Date: January 21st, 2016
Project No. 1417

ADDENDUM NO. 04

To the drawings and specifications for:
Fire Station 30
911 Gemblar Road,
San Antonio, Texas 78219

REPLACED DRAWING SHEET: IT401

SHEET NUMBER
IT401

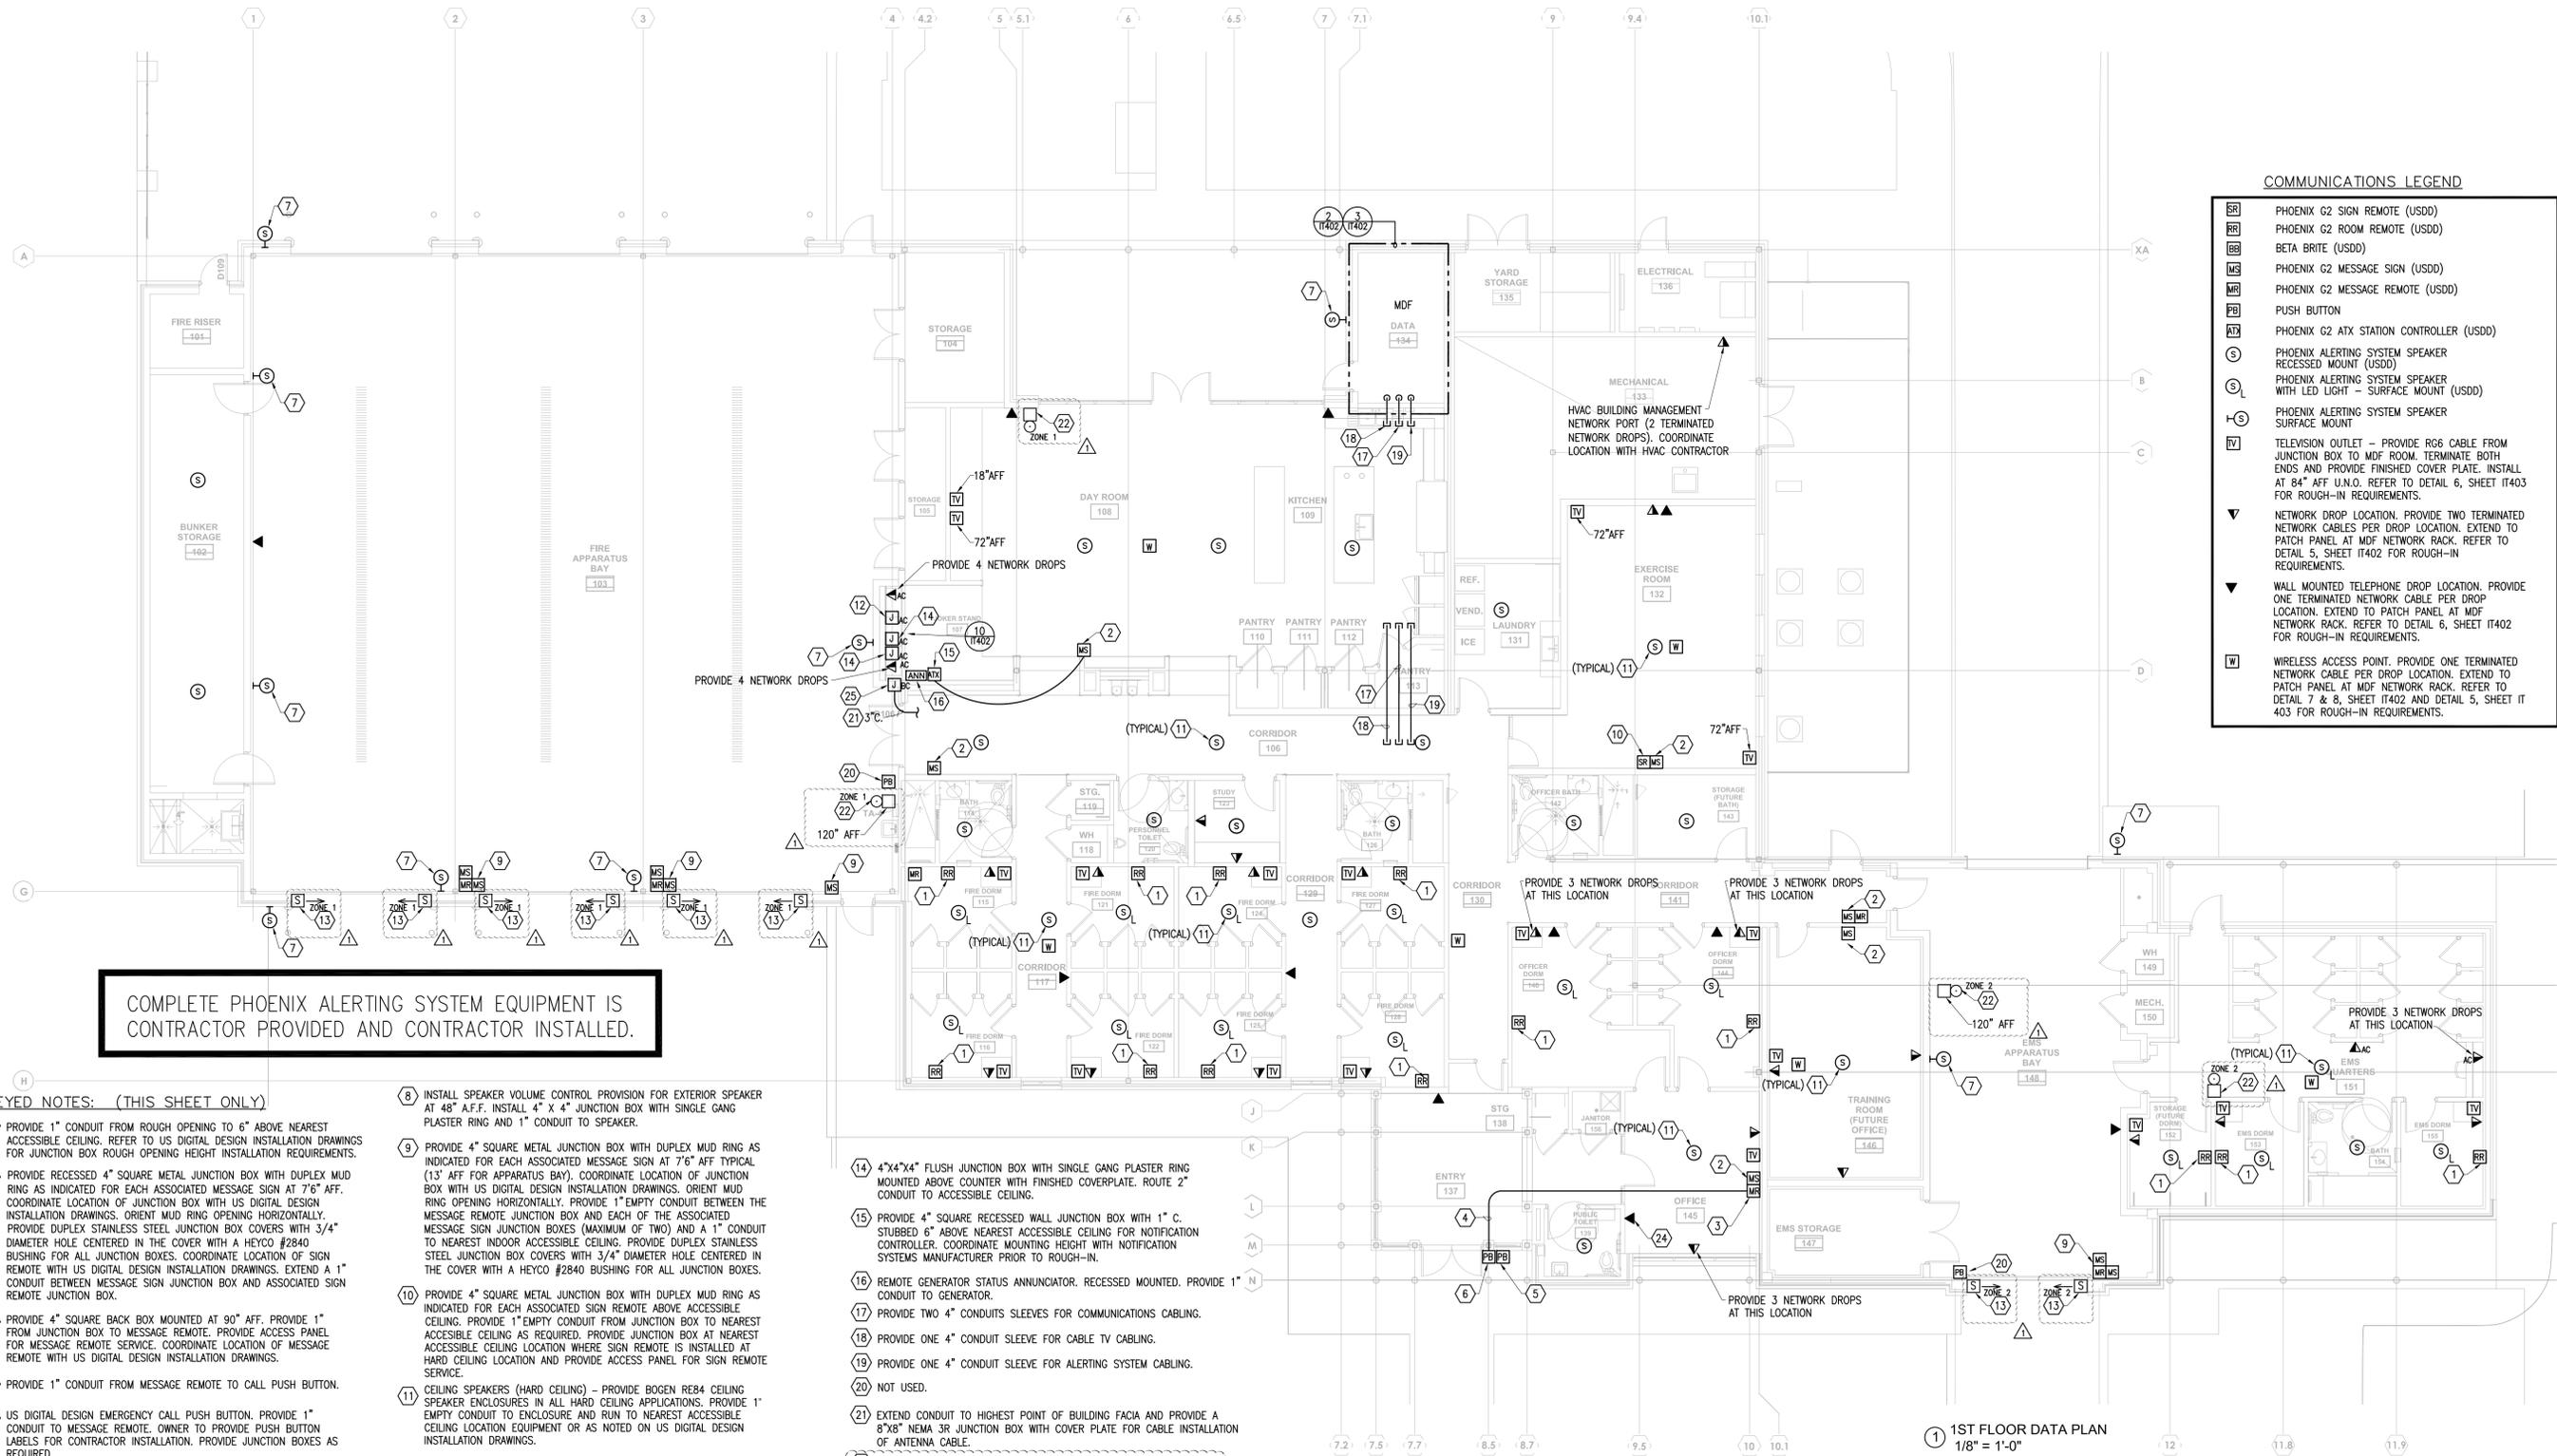
Item 4.1 IT Sheet 401 has been updated to include general note 9 and the addition of apparatus bay door sensors/chime system. Refer to attached Addendum No. 4 narrative from CNG Engineering.

Item 1: Added apparatus bay door sensors/chime system.

- DUAL BEAM PHOTOELECTRIC SENSOR EQUAL TO OPTEX AX-70N. PROVIDE REQUIRED POWER SUPPLY AND ACCESSORIES FOR A COMPLETE INSTALLATION. CONNECT TO INTRUSION ALARM BELL/CHIME. PROVIDE WITH OPTEX TC-10U WIRELESS TRANSMITTER.

- INTRUSION ALARM BELL/CHIME. PROVIDE EQUAL TO OPTEX RC-20U. PROVIDE 120V POWER RECEPTACLE FOR AC ADAPTOR.
- ALERTING SYSTEM VOLUME CONTROL PUSHBUTTON. PROVIDE SINGLE GANG JUNCTION BOX WITH 1" CONDUIT TO NEAREST ACCESSIBLE CEILING. PUSH BUTTON AND WIRING TO BE PROVIDED AND INSTALLED BY OWNER.
